STATE OF IDAHO
DEPARTMENT OF WATER RESOURCES
BENEFICIAL USE FIELD REPORT

Permit No: 22-13709

Exam Date: 6/11/2014

Re: Permit No, 22-13709

Pond # 1 – Surface water inlet, looking East

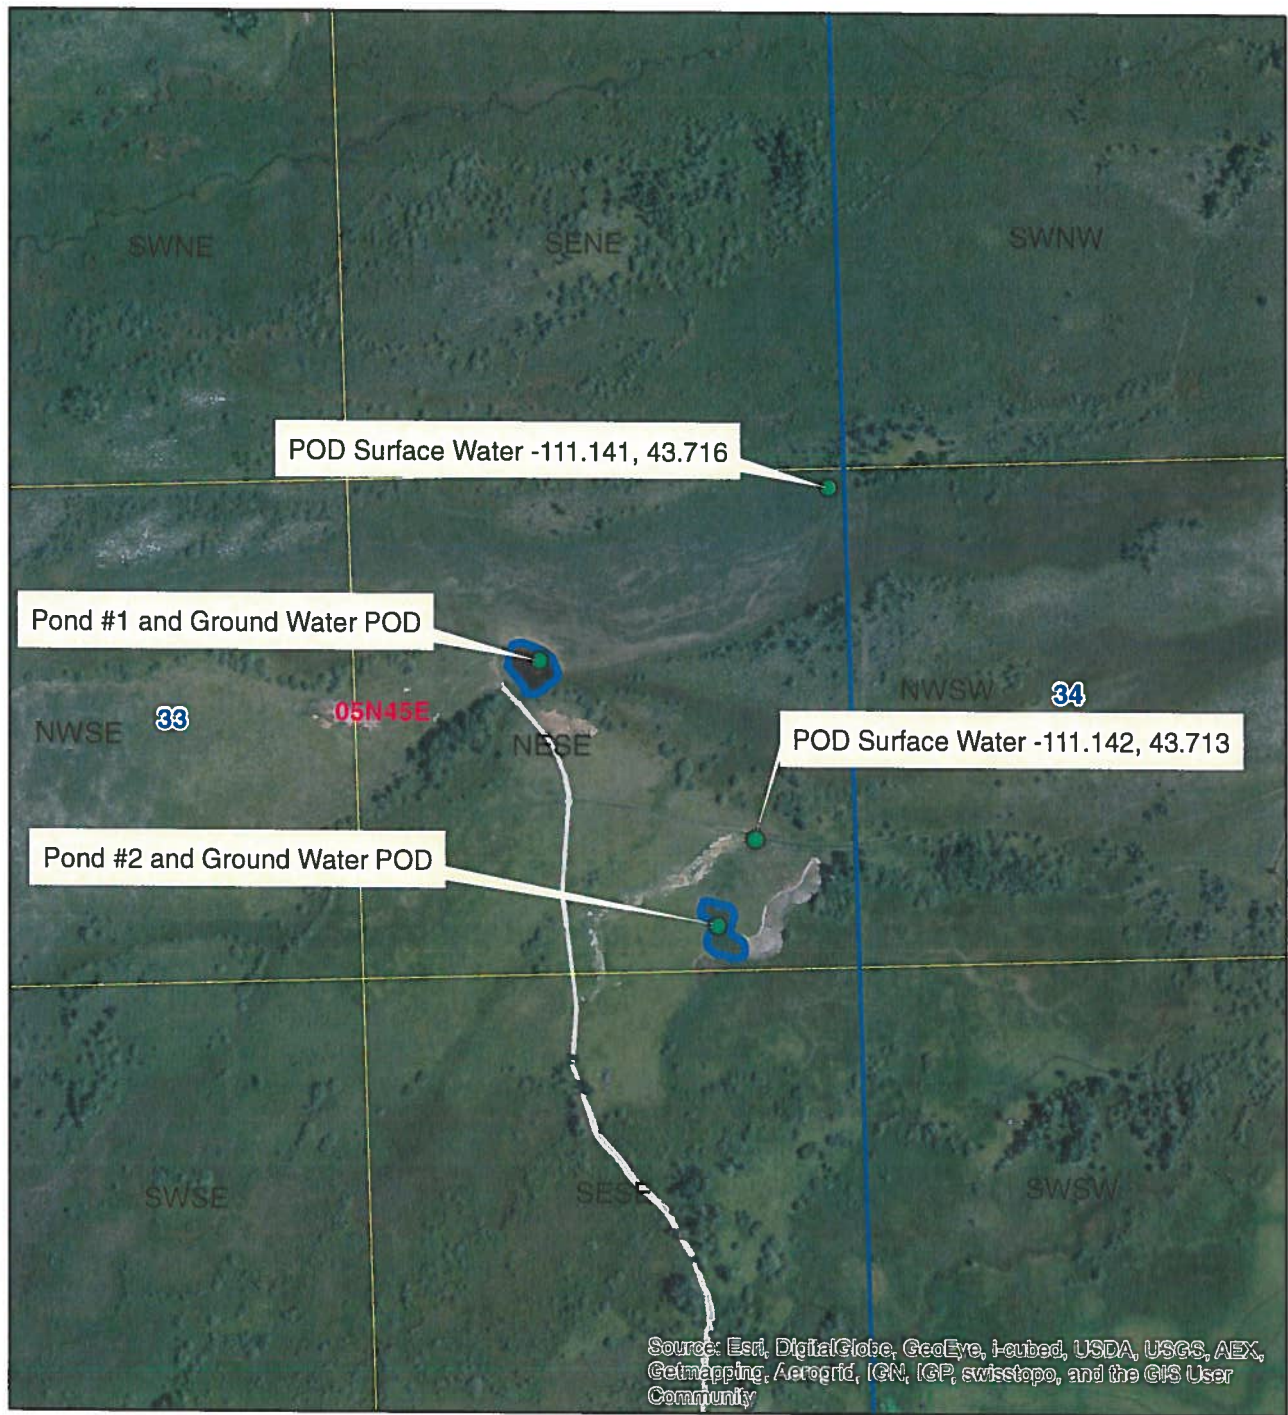
Completed BUE 6/11/2014, POD and POU for pond #2 is in the wrong location. There was no surface water flow into Pond #1 at the time of the field exam. However, there has been surface water flow recently into this pond based on soil and vegetation conditions. Pond #2 has surface water flow, however there is only one POD listed for surface water and there are clearly two surface water POD's and two groundwater POD's. The application and supporting permit documentation are ambiguous and another surface water POD should have been added at the time of application.

1. Headgate and ditch transporting irrigation water to Pond 2.

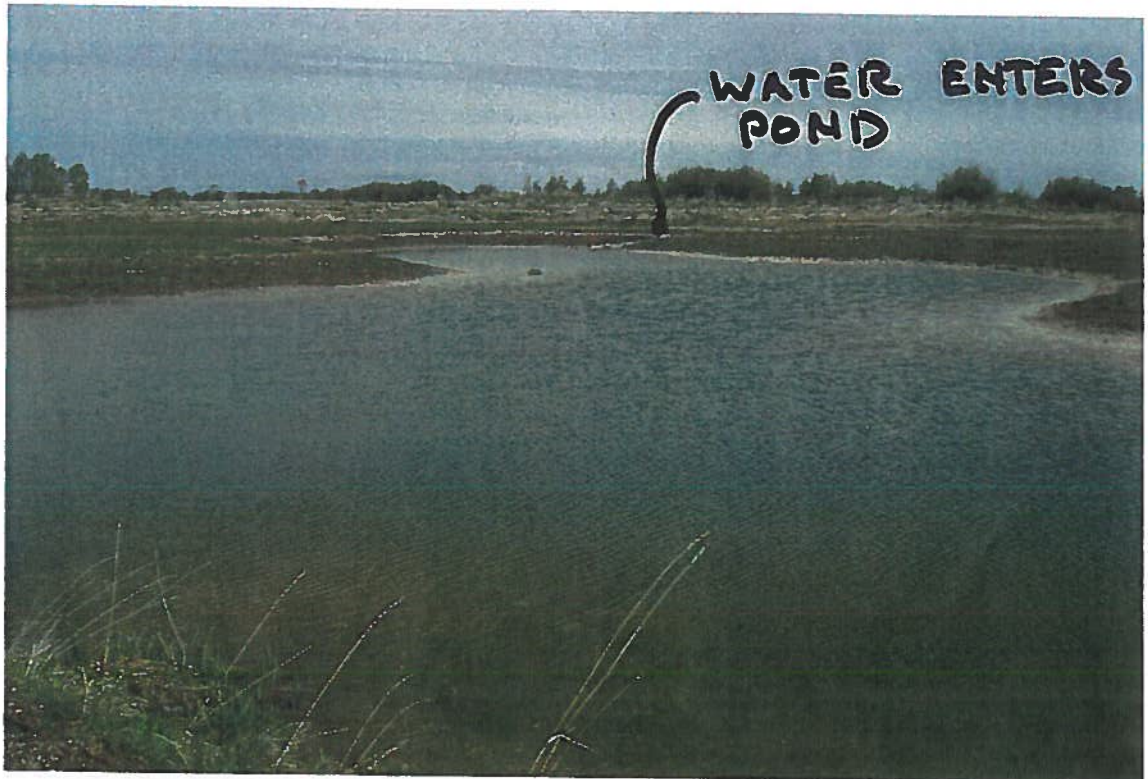
There is a relatively new headgate to the southern most of the two ponds (Pond 2). This headgate facilitates water management between the pond and a tributary ditch. The head gate can be altered to become a lockable gate, but that does not seem to be necessary since water cannot be conveyed to a downstream user via the ditch to the pond or via its tributary ditch. Again, all irrigation water passing through these two ditches ultimately spreads out over pasture on the subject property.

2. Pond 2 is largely sustained by groundwater, but some irrigation water will be used to top-off pond.

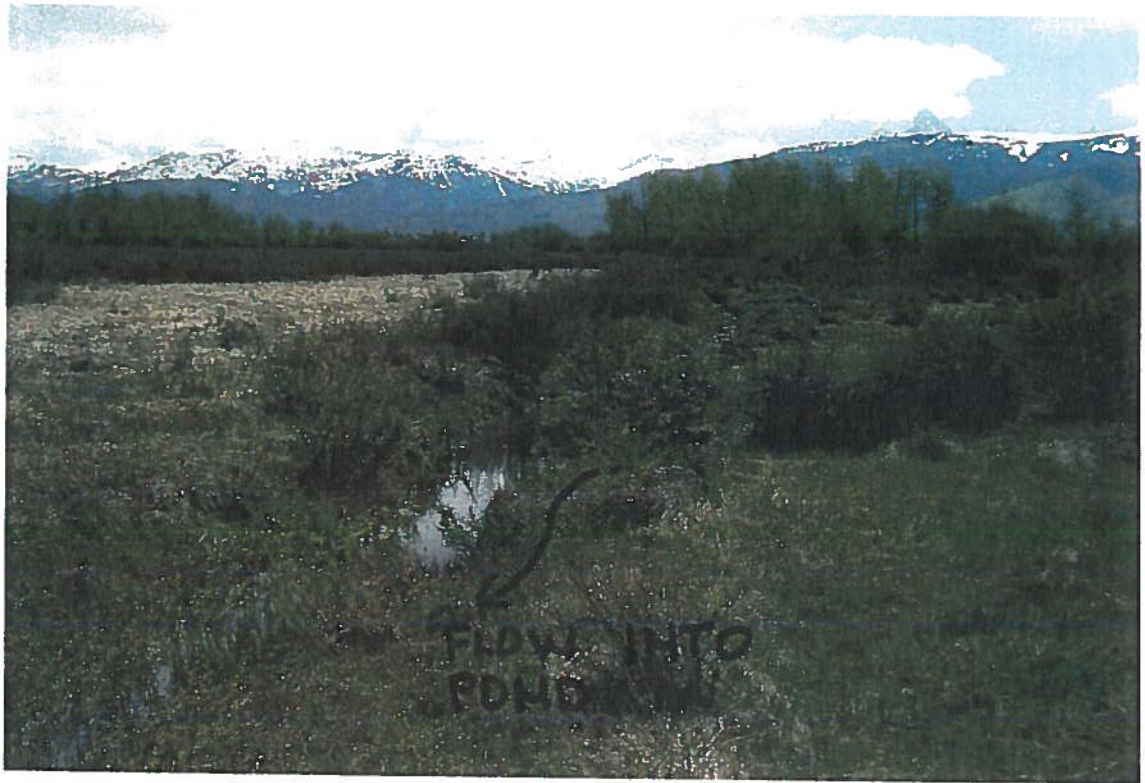
Each pond is at the terminus out an irrigation ditch that transports water from the neighboring property to the East. If water overflows either pond there is no ditch or other conveyance to transport water downstream to the west (see attached map of Pond Locations). On those occasions when there is overflow water, it spreads out in wetlands and pastures to the west of the ponds. Since there is no means of transporting water to a downstream user, lockable headgates and measuring devices seem unnecessary. Furthermore, the ponds only receive irrigation water when the landowner to the east can divert it to them. This arrangement is completely acceptable to Idaho Holdings, LLC. There have been no complaints or problems with the amount of water received. Indeed, the ponds are largely sustained by groundwater from a shallow watertable. This is solely a water storage right.
